FINAL DRAINAGE REPORT FOR SADDLEHORN RANCH – FILING 4

> June 9, 2023 Project No. 25142.06

SF-23-006

Final Drainage Report Filing 4 - Saddlehorn Ranch

EXISTING CONDITIONS MAP SADDLEHORN RANCH FILING 4 JOB NO. 25142.06 4/21/23 SHEET 1 OF 1

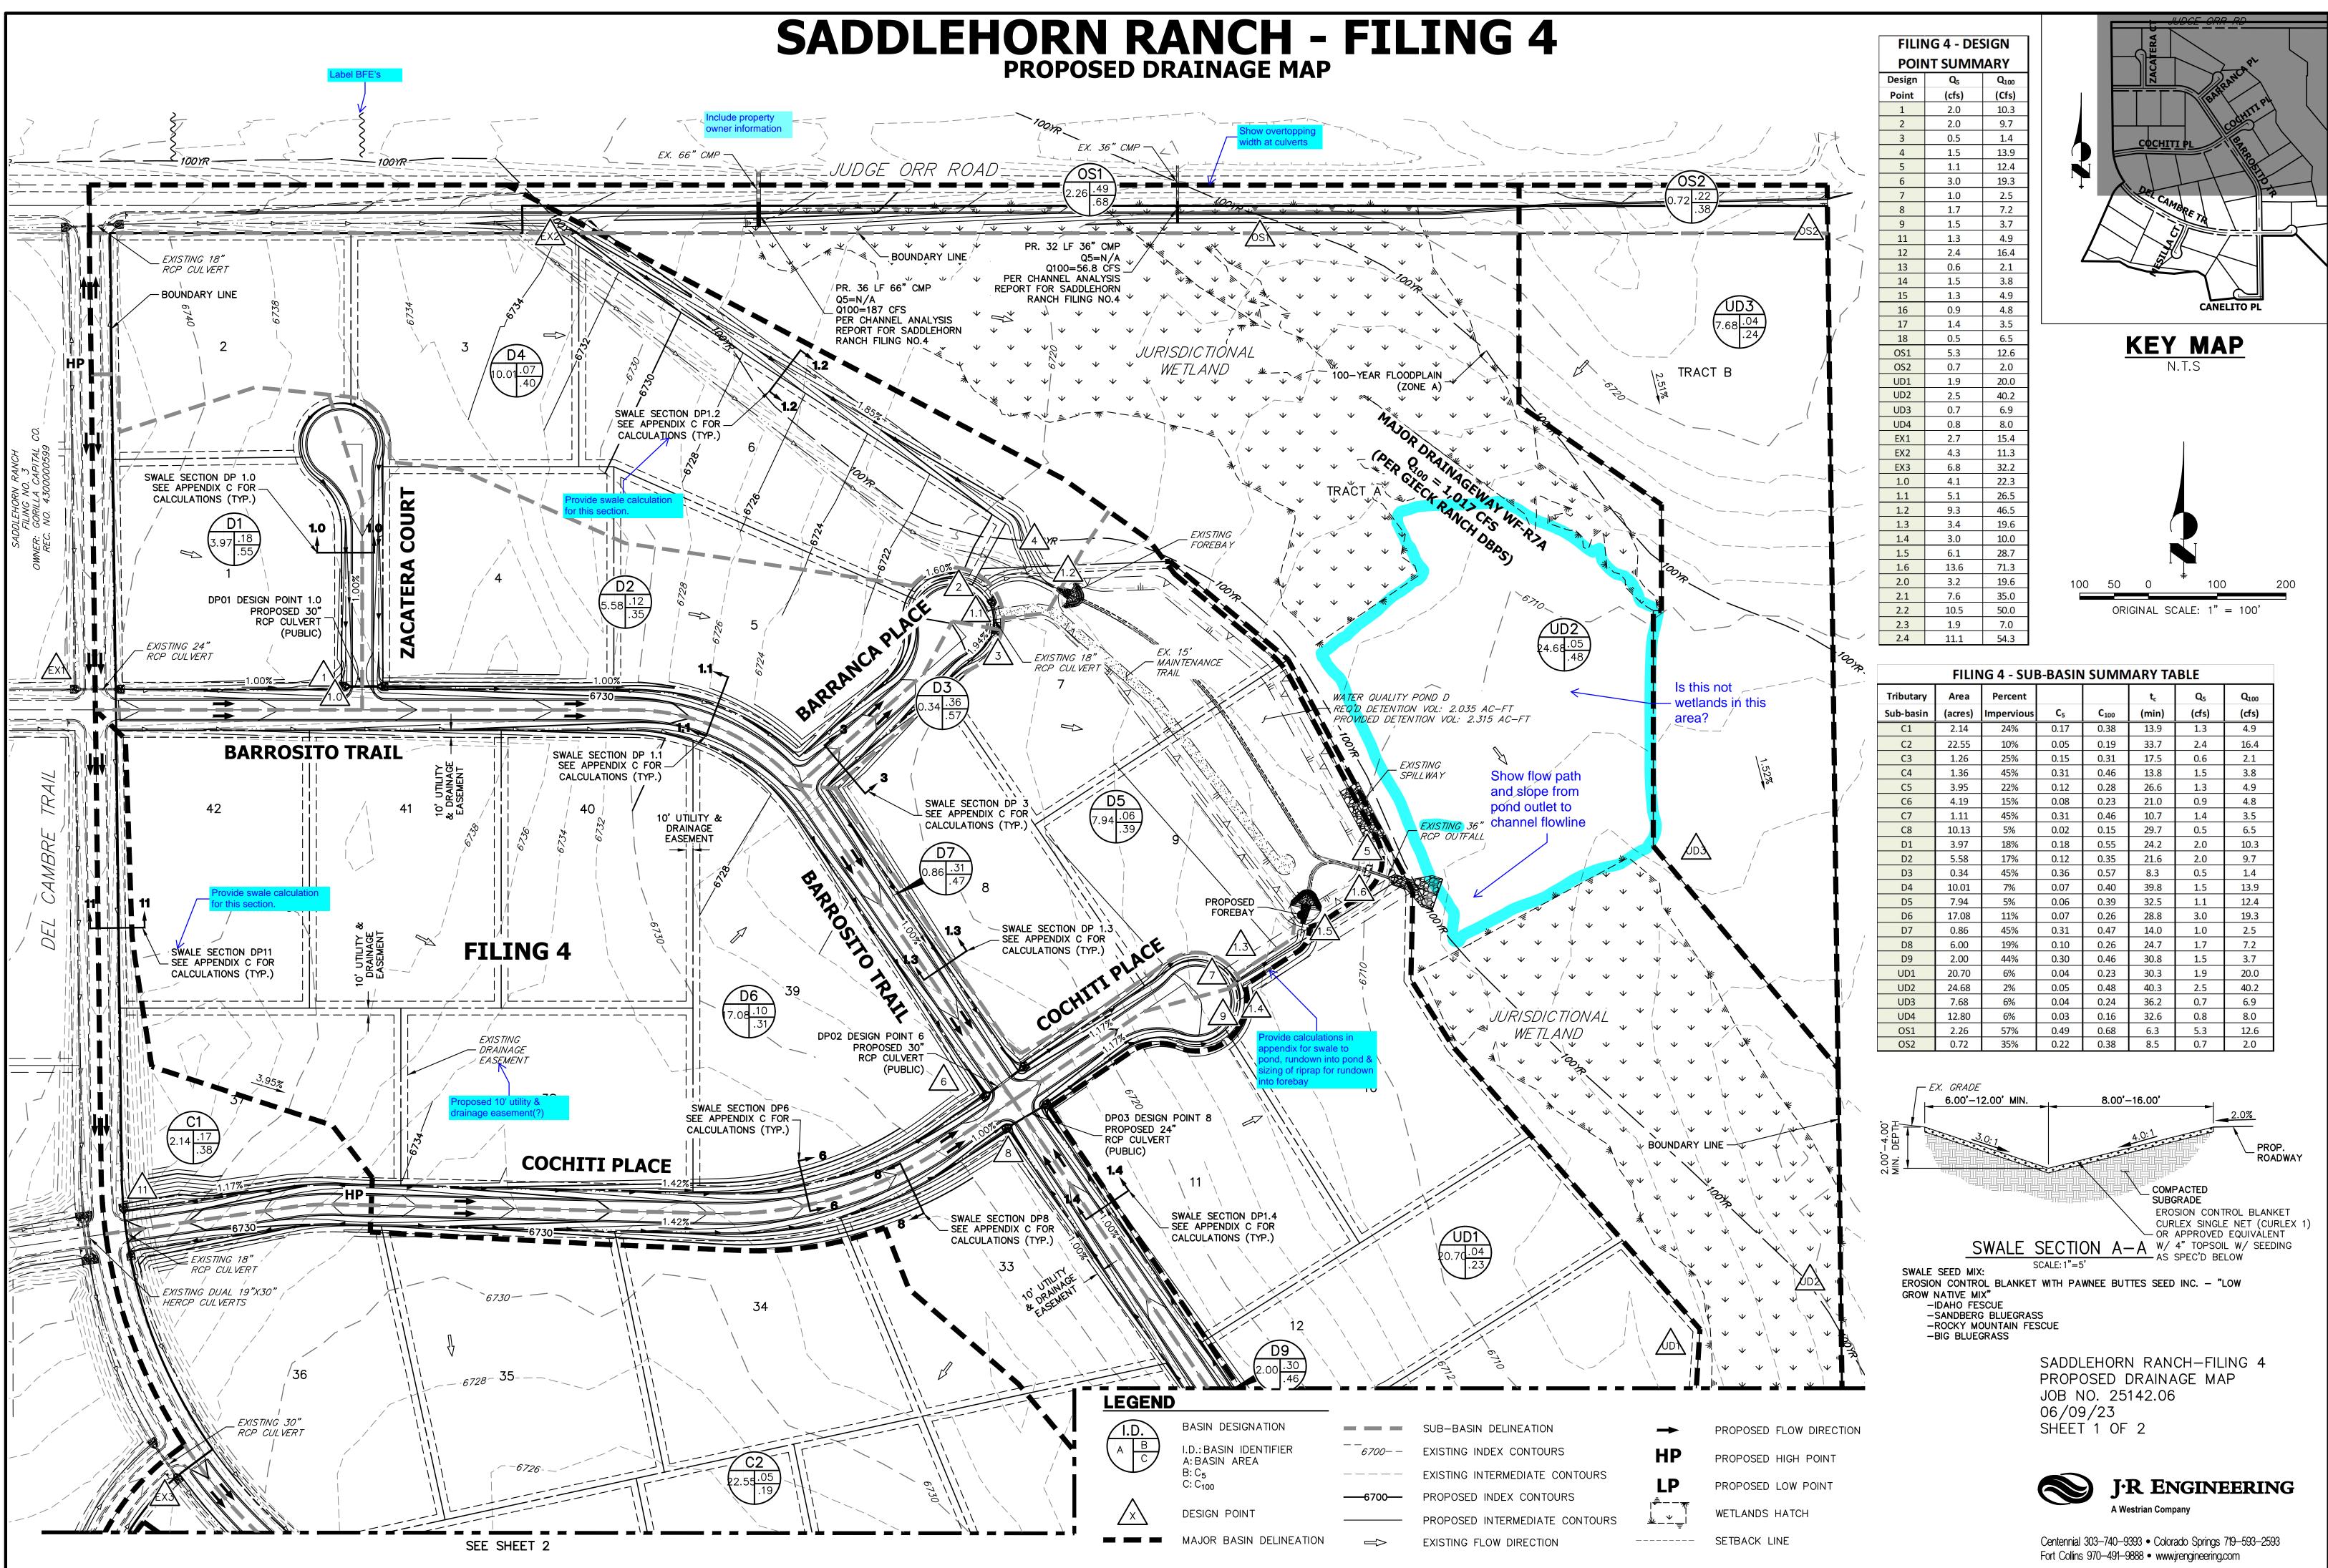
and Preliminary Drainage Report for Saddlehorn Ranch. An existing drainage map and existing drainage calcs have been provided in Appendix E. A Filing 4 Existing Conditions Drainage Map has been provided in Appendix F. Please provide calculations corresponding to this map and add discussion within report as well
